21/0496 Land off IKEA Way: Exeter Cycling Campaign Response

The Exeter Cycling Campaign welcomes the opportunity to comment on the application/appeal : 21/0496 - development on land off IKEA Way Exeter : (19/1647/FUL also refers).

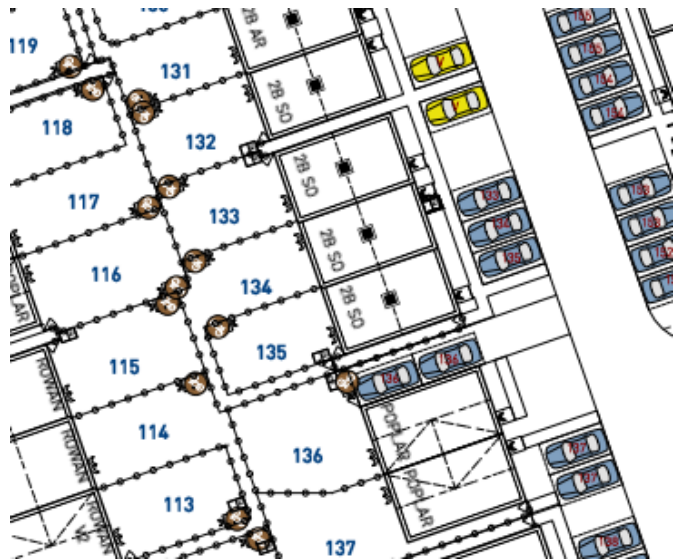
Recent new developments in Exeter have quickly become dangerous places for children to navigate because their roads and pavements are used to park vehicles. We ask that measures are built into the design of the road network for this development that ensure the public highways (including the pavements) are kept free from parked vehicles.
